RE: La Rinconada Facilities

I reviewed the drawings, and evaluated the site context. My comments and recommendations are as follows:

BUILDING 1

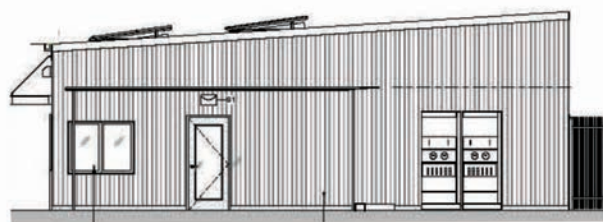
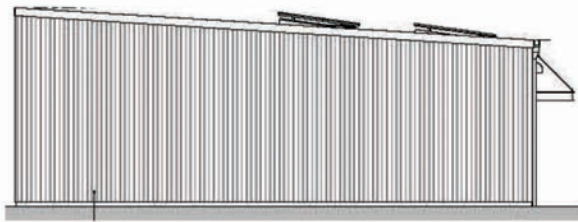
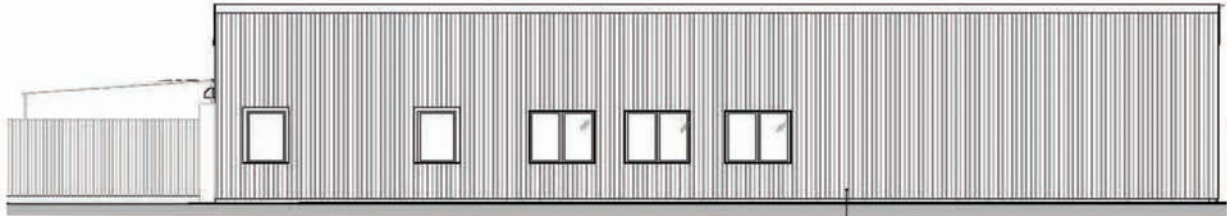
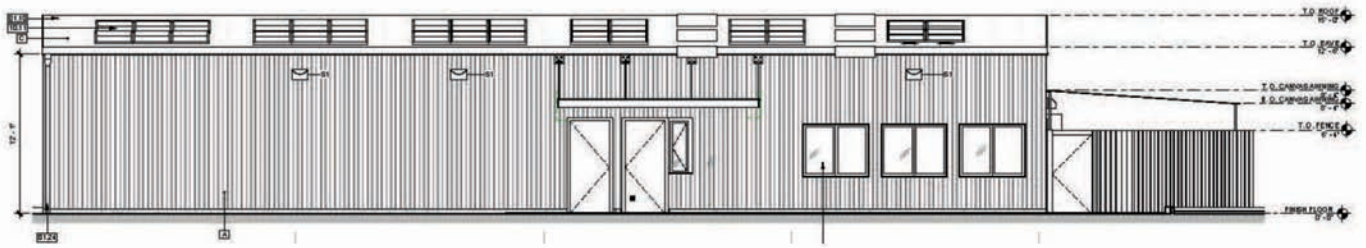
1. The proposed buildings are typical metal panel maintenance buildings. Each manufacturer has slightly different details and no typical details for the proposed buildings were provided in the submission drawings. There is one element that needs further explanation. The Building 1 elevation below shows different window trim on the same elevation.

1. Staff may want to ask the applicant for more manufacturer's details and photos of the proposed buildings.
2. The proposed color scheme, as noted, is quite bland while many similar golf course maintenance buildings have a bit more life to them. Consider a different combination of colors.

BUILDING 2

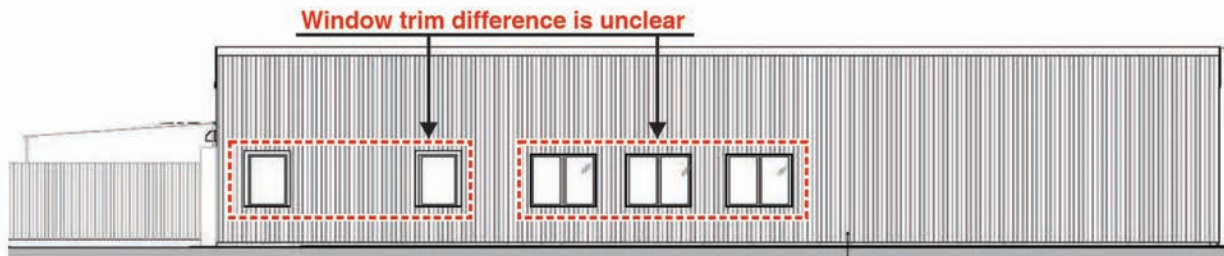
2. The proposed color scheme for the new buildings is quite bland with Ash Gray wall panels and White standing seam roofing.
